October 25, 2006

**Subject: Gentilly Landfill Potential Influences on Reliability of Adjacent ICWW/MRGO Flood Protection Levee**

Figure 1: Probabilities of failure as functions of the Factor of Safety (FS50) and total uncertainties ( $\sigma$ )

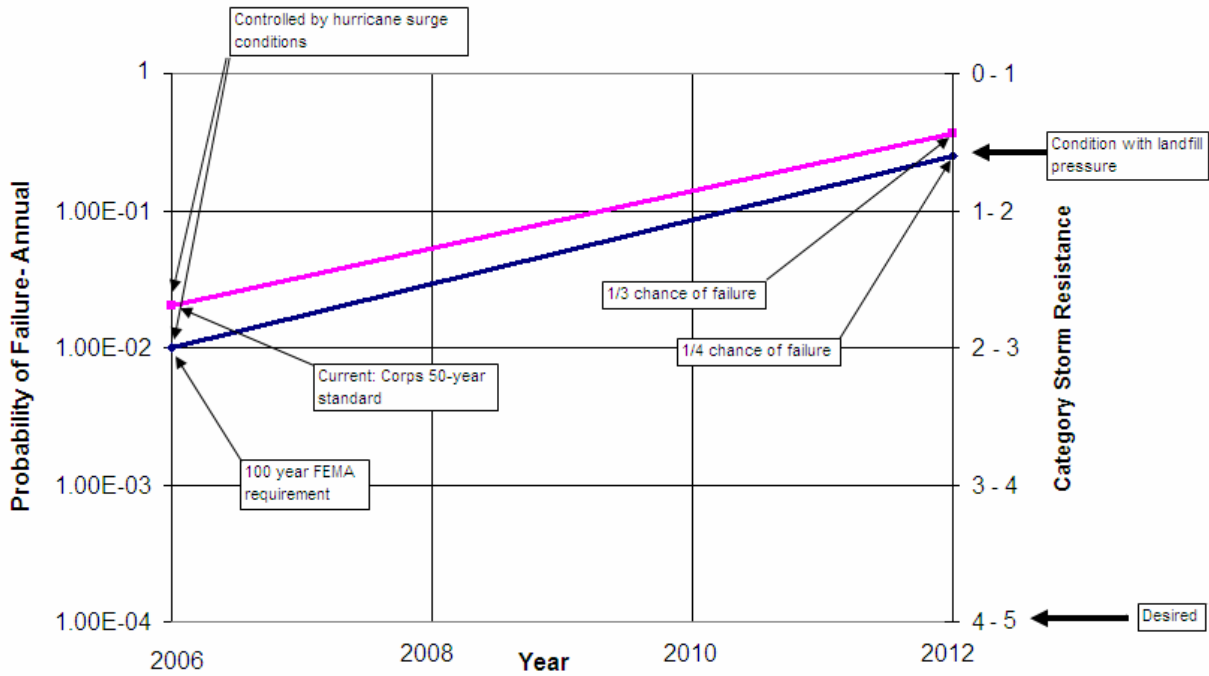
Given the range of factors of safety cited, the preliminary analyses indicate total uncertainties (expressed as the logarithm of the standard deviation of the slope stability demand and capacity) of 60% to 70%. These values are based on demand uncertainties (primarily dependent on the long-term effective compacted unit weight of landfill) in the range of 40% to 50%, capacity uncertainties (primarily dependent on effective shear strengths of the affected soils) in the range of 30% to 40%, and analytical model (circular arc slope stability) in the range of 20% to 30%. The analyses have assumed that the analyses that have been performed have been based on 'best estimate' values and that there are no systematic 'biases' that have been introduced into the computed factors of safety.

The resulting probabilities of failure (likelihood that the slopes are 'unstable', deform excessively) are in the range of 25% to 37% (Figure 1). These results can be interpreted as about one chance in three (1/3) that the adjacent flood protection levee will be seriously impaired (slope stability failure) when the proposed landfill is completed (2012).

Explanation of Figure 1. The probability of failure (Pf) is the probability or likelihood that the demand (loads, stresses) imposed by the proposed landfill (final condition) will equal or exceed the capacity of the landfill, underlying and adjacent soils to resist the demand without failing (excessive displacements). Failure is determined as the condition when the imposed demand exceeds the available capacity. The distributions of the slope stability demand and capacity have been evaluated to be well characterized with Lognormal distributions. The factor of safety (FS50) is expressed as the ratio of the median (50-th percentile) demand to the median capacity (this presumes that there are no systematic 'biases' present in the referenced analyses. The factor of safety has been determined from the geotechnical stability analyses. The total uncertainty in demand and capacity ( $\sigma$ ) is determined from the standard deviations of the logarithms of the demand ( $\sigma_D$ ) and capacity ( $\sigma_C$ ,  $\sigma^2 = \sigma_D^2 + \sigma_C^2$ ). The uncertainties in demand and capacity have been determined from the available data on soil strengths, unit weights of the fill, and accuracy of the analytical model employed to determine the factor of safety.
